R7 M A RESOLUTION OF THE MAYOR AND CITY COMMISSION OF THE CITY OF MIAMI BEACH, FLORIDA, APPROVING THE DESIGN FOR THE 41ST STREET CORRIDOR REVITALIZATION PROJECT, INCLUDING CERTAIN ADDITIONAL SCOPE ITEMS AS RECOMMENDED BY THE COMMUNITY, DESIGN REVIEW BOARD, AND THE MAYOR'S 41ST STREET BLUE RIBBON COMMITTEE, WITH ADDITIONAL FUNDING TO BE REQUESTED THROUGH THE FISCAL YEAR 2026 CAPITAL BUDGET PROCESS.

COMMISSION MEMORANDUM

MIAMI BEACH 41 STREET CORRIDOR REVITALIZATION PROJECT

DESIGN REVIEW BOARD PRESENTATION
JULY 2, 2024

LIGHTING OPTION 2

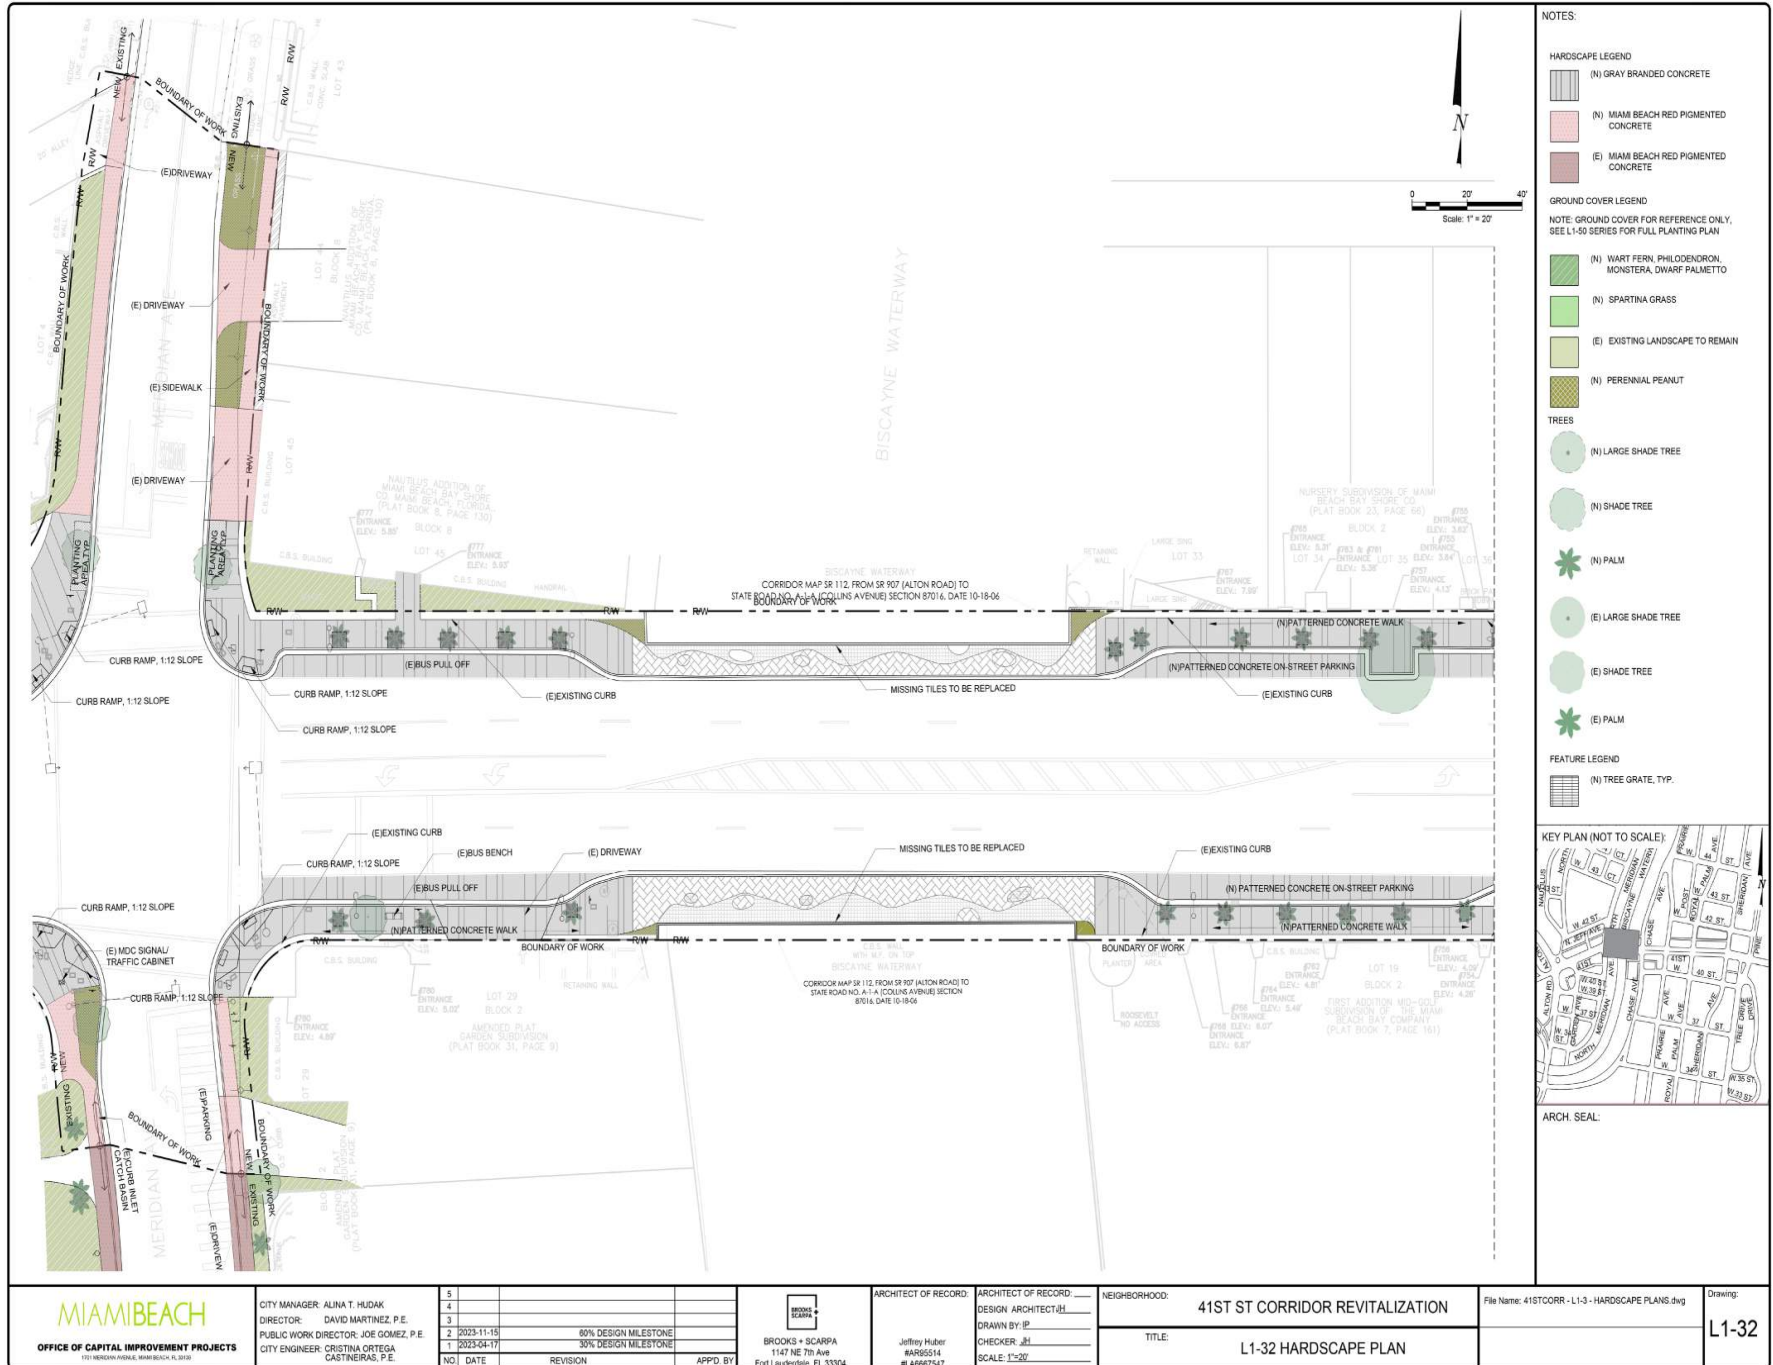
3. The preferred option of the artistic lighting is option #3, with the circular downlights on poles. Option 1, with vertical beacon lights on the top of poles, was not recommended.

1. Explore utilizing other bright colors (besides Miami Beach pink) for the canopy structures.
2. Miami Beach pink is acceptable for the sidewalk pavement and furniture that emerges from the sidewalk.
3. Miami Beach pink sidewalks should have the same branding features as the grey sidewalks.
4. Utilize the proposed canopy structures to provide shade
5. Utilize the proposed canopy structures to call attention to and embrace the palm trees or shade trees.
6. Option 2 regarding lighting (up and down light for every other Royal Palm tree) is recommended.

The Administration recommends approval of the design, including the replacement of the temporary string lights with permanent up and down lights at every other palm tree, and providing the electrical infrastructure for LPR cameras. The Administration does not recommend the replacement of the existing Acorn light fixtures and poles, for the reasons noted above. Funding for the additional scope will be requested through the Fiscal Year 2026 Capital Budget process.
